Addenda No. 3

PREPARED BY: Michael Gumbel

SUBJECT: OR 99/238 Paving (Grants Pass) Section
Rogue River/Jacksonville Highway
Jackson County
Paving & Drainage Project
(Bids to be opened and read January 22, 2009)

SHEET NO. **2B**

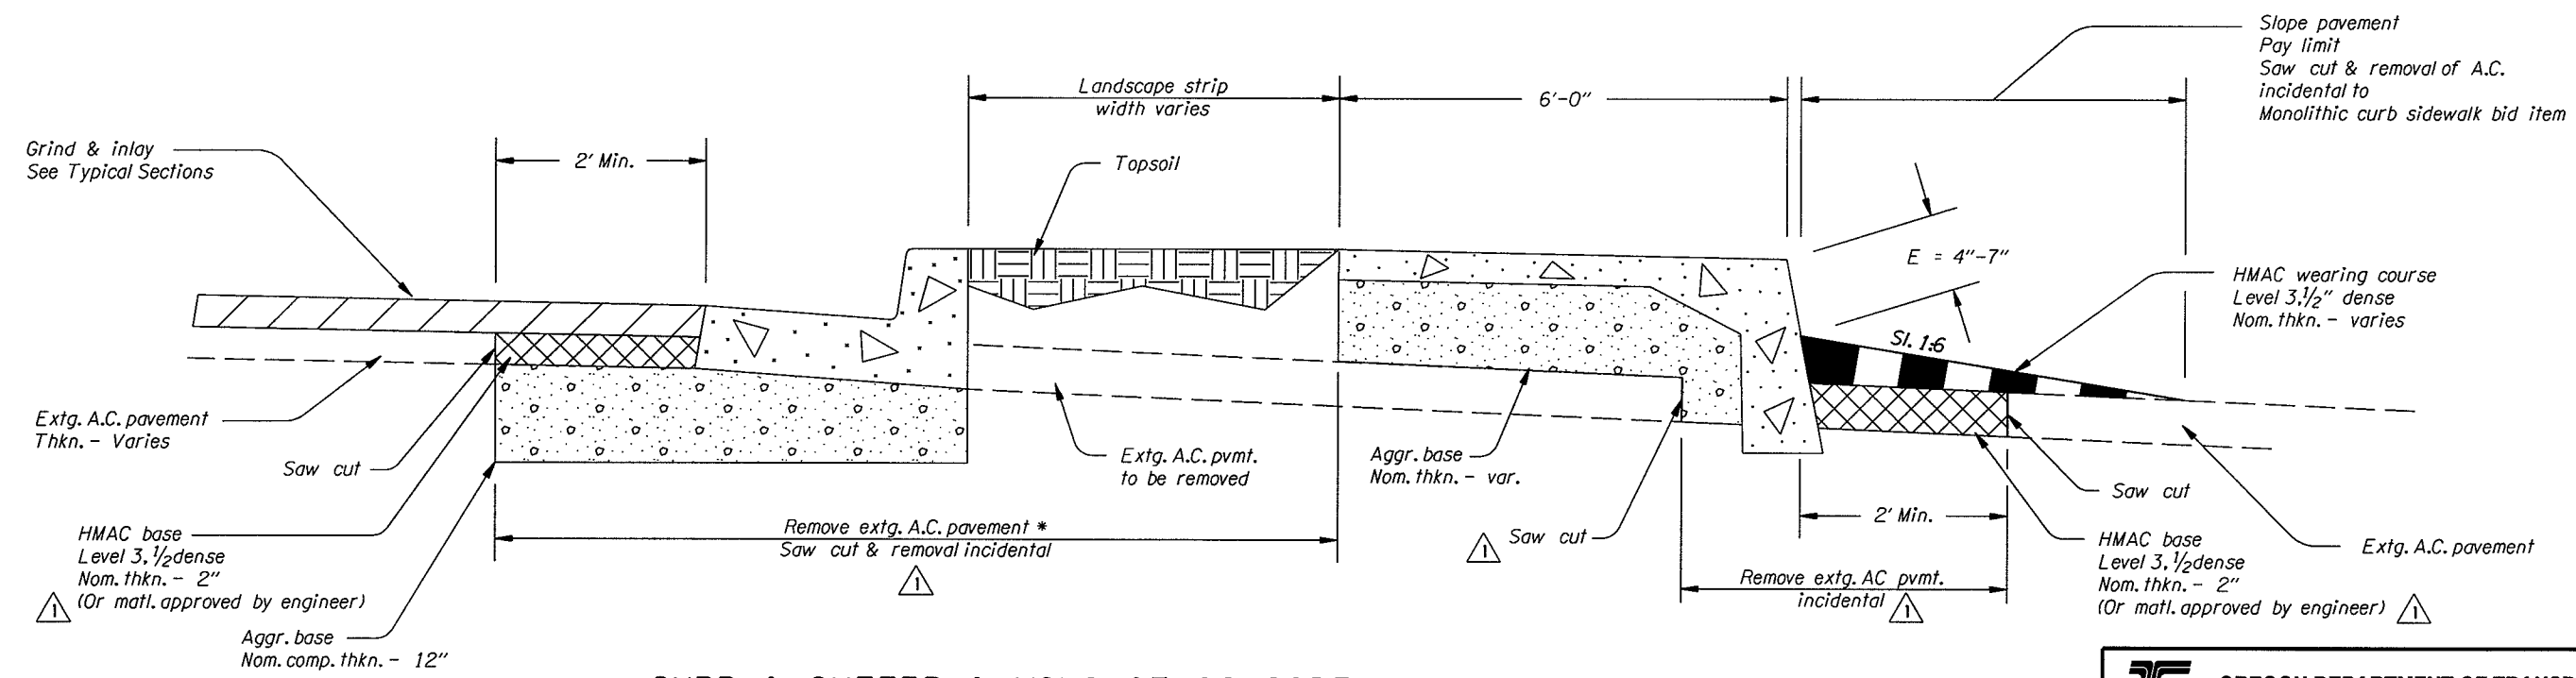
| Rev. No. | Description | Date | Engineer |
|----------|----------------------------------------|--------|--------------|
| 1 | Changed monolithic curb sidewalk shape | 1-9-09 | Chris Zelmer |

SHEET NO.
4B

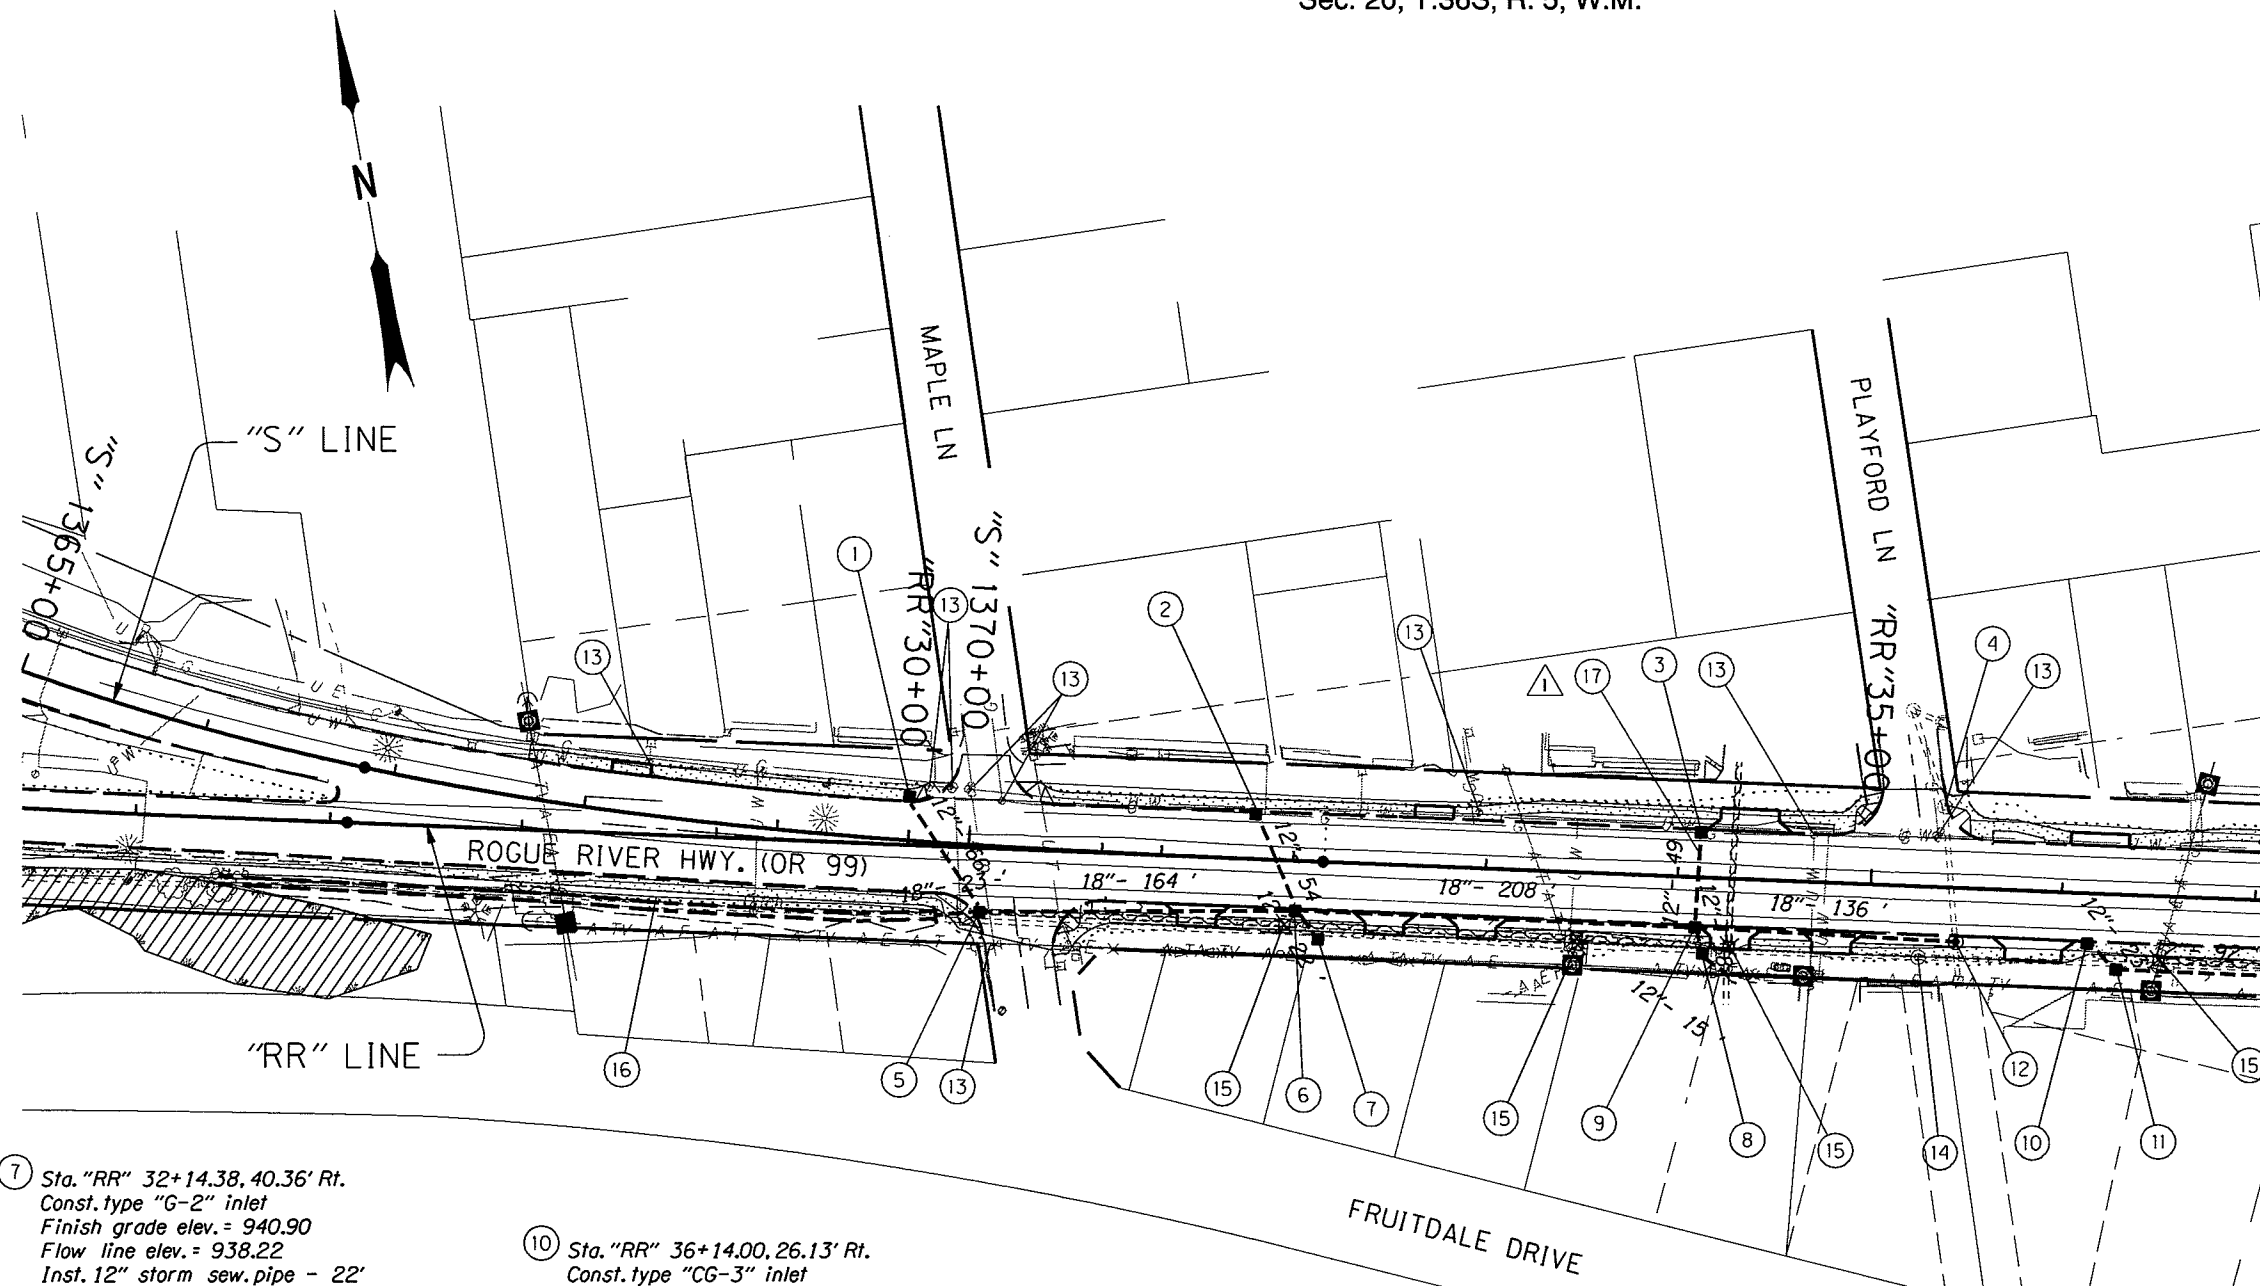
| Rev. No. | Description | Date | Engineer |
|----------|---------------|---------|--------------|
| 1 | Added note 17 | 1-12-09 | Chris Zelmer |

- ⑭ Minor adjust manhole
- ⑮ Remove inlet - 5
- ⑯ Sta. "RR" 26+25.00 - 30+14.64 Rt.
Const. V bottom ditch with 1:2 side slopes
Ditch exc. - 93 cu. yd.
- ⑰ Inst. 6" PVC Pre-plumbed
Irrigation sleeve in common trench
with storm drain (See landscape plan)

PROFILE

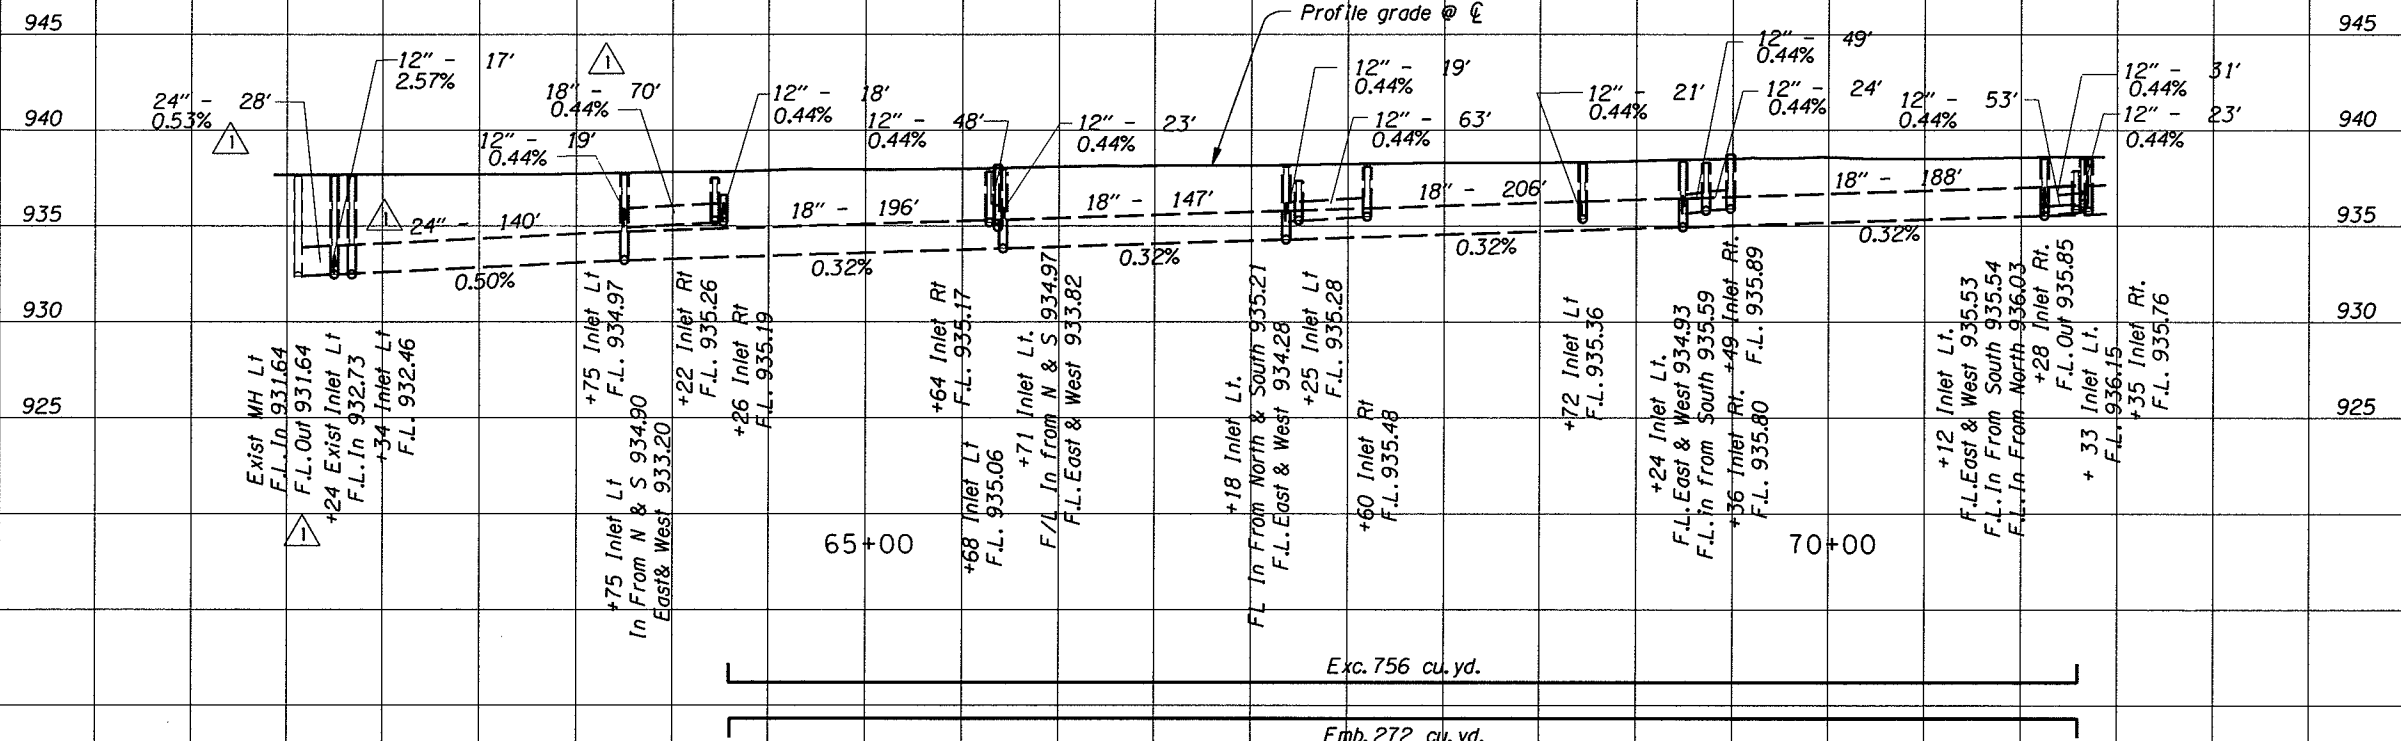
| Rev. No. | Description | Date | Engineer |
|----------|----------------------------------------------------------------------------|--------|--------------|
| △ | Increased pipe diameters 12" to 18" & 18" to 24" F.L Out was: 932.28 | 1-9-09 | Chris Zelmer |

SHEET NO. 7A

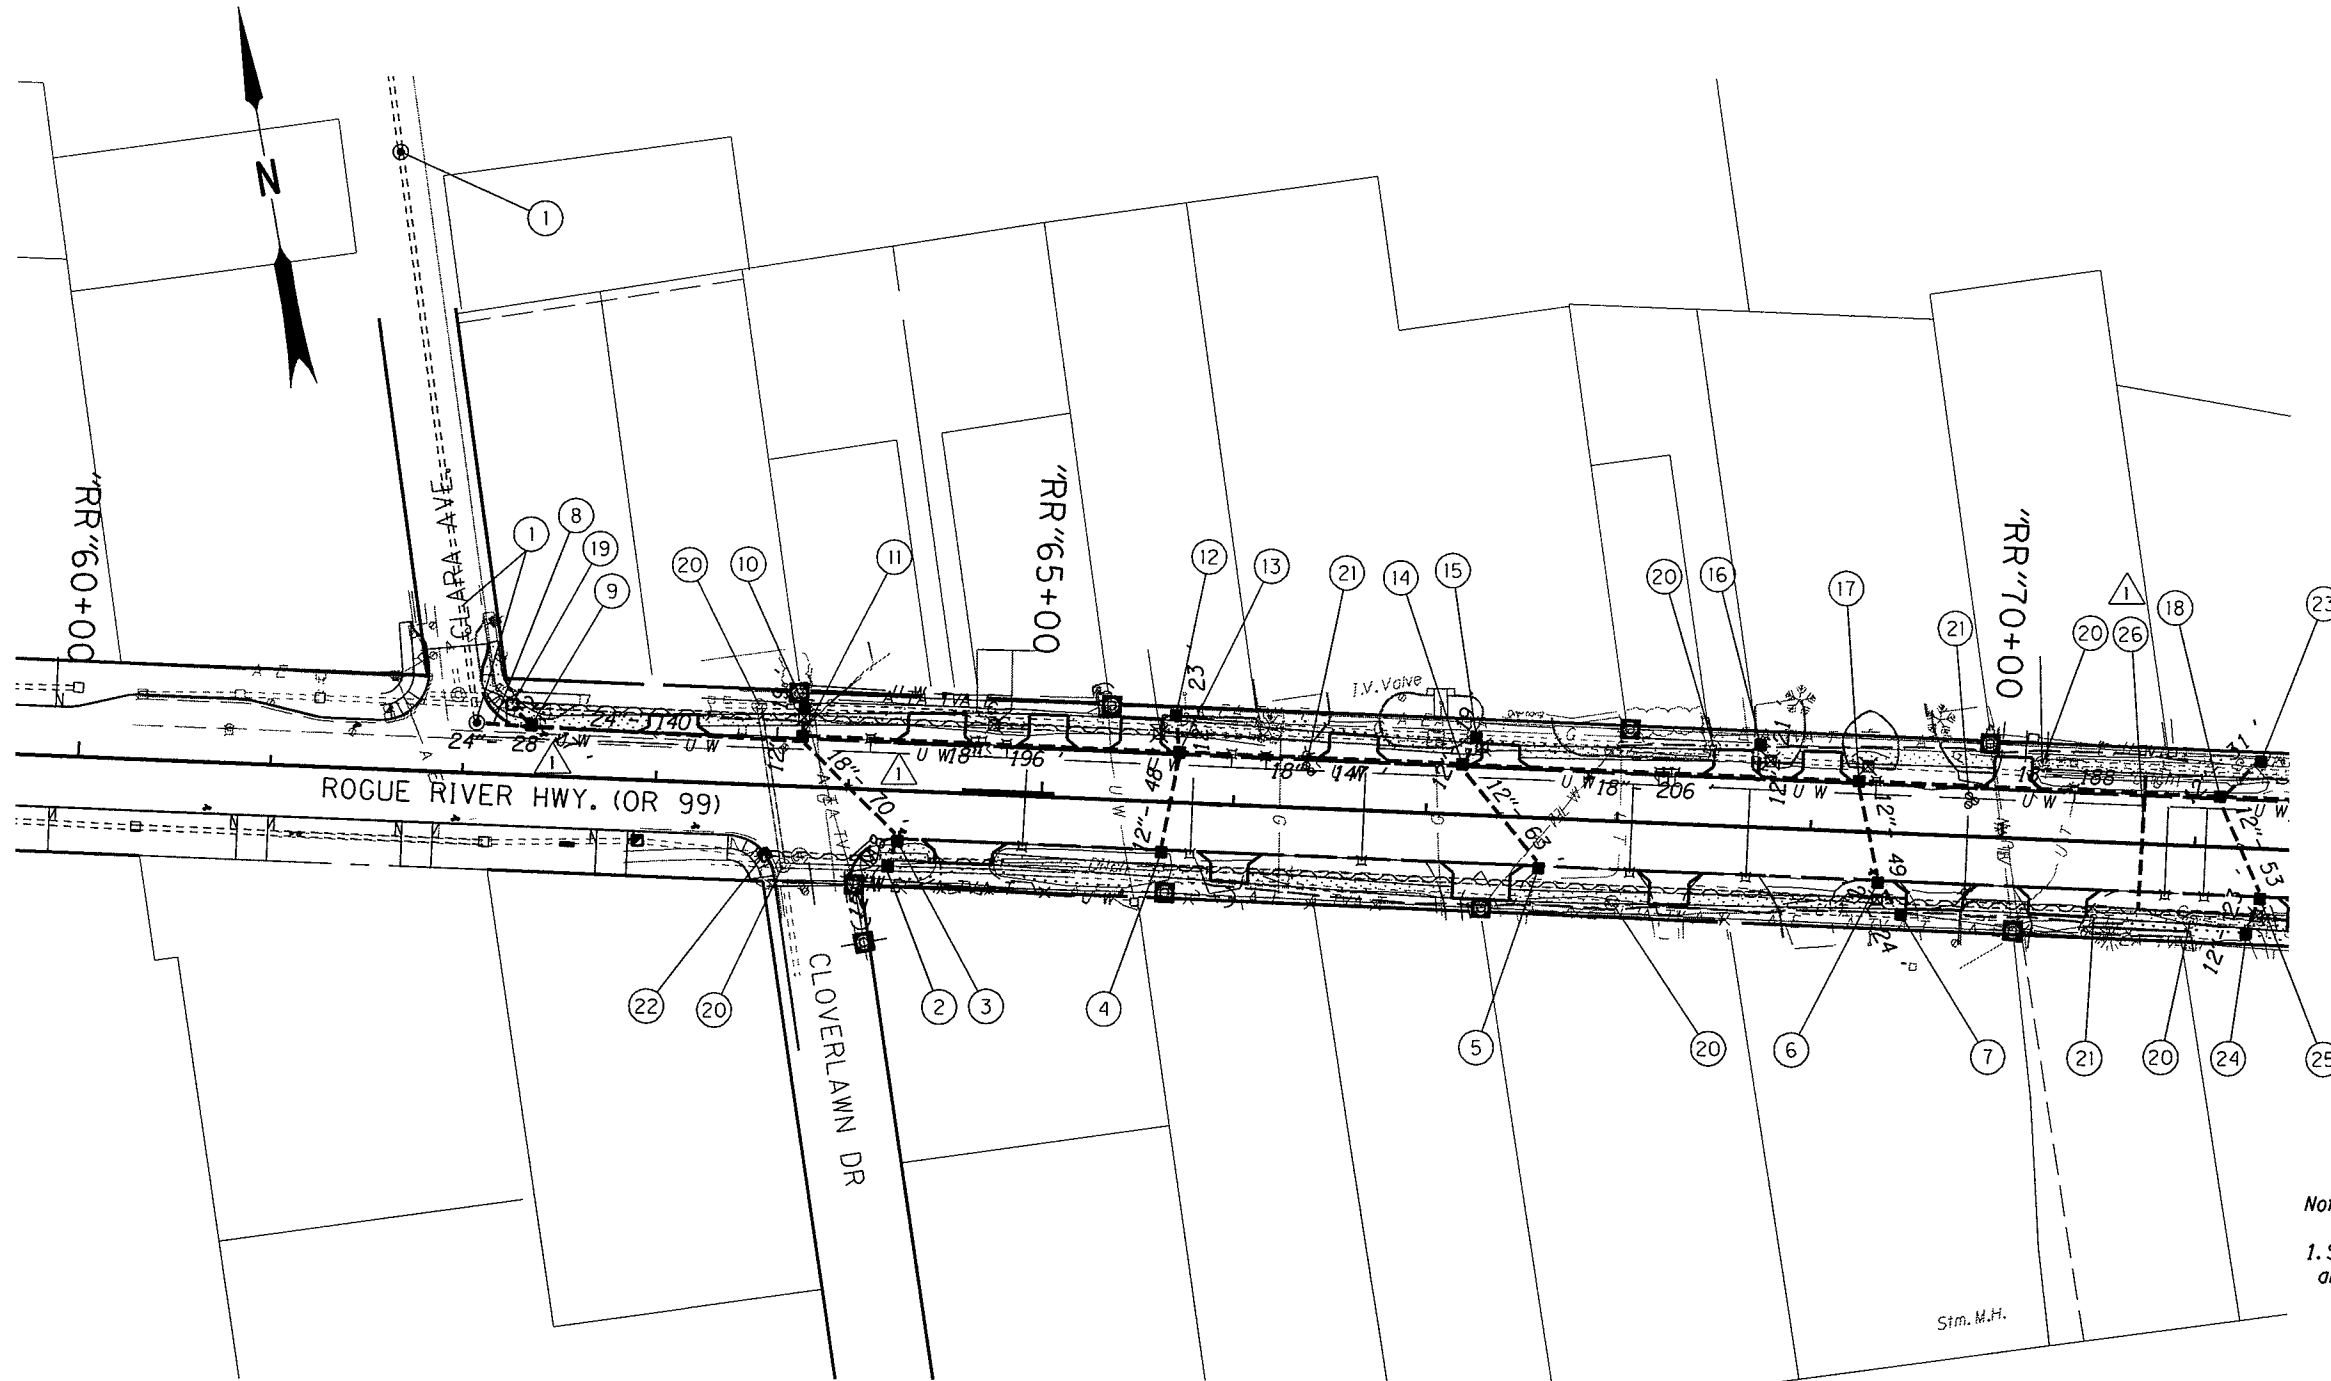
| Rev. No. | Description | Date | Engineer |
|----------|---------------------------------------|---------|--------------|
| 1 | Chgd notes: 8, 9, & 11, added note 26 | 1-12-09 | Chris Zelmer |
